Service Bulletin

Product category:	Tumbledryer
Affected models:	CTT7800V, CTT7100V
Release:	1.0, 2023-04-03

Compressor terminals falls off

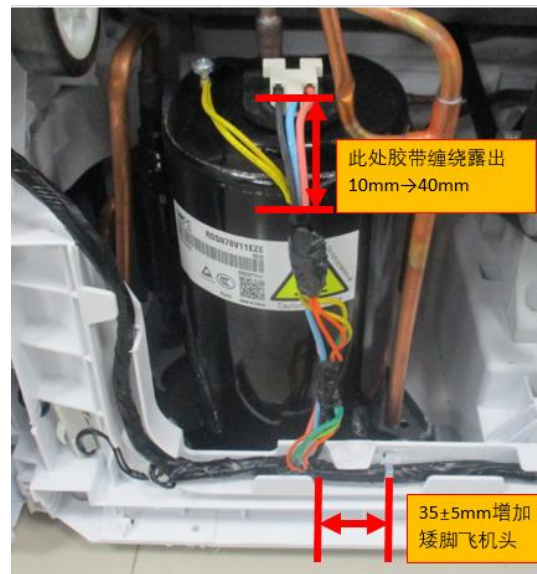
Due to too stretched cables in harness up to the compressor terminal there has been cases where the compressor terminal comes loose caused by vibrations from transporting the product and when the machine is running. The most common error description from the customer is poor/no drying.

Remove black tape from the terminal and 40 mm down on the harness.

Pull harness at the bottom to the right about 35 mm and fix it with a new cable tie.

Important! Make sure no electrical cables are in contact with or at risk to any refrigerant pipes. Risk of fire!
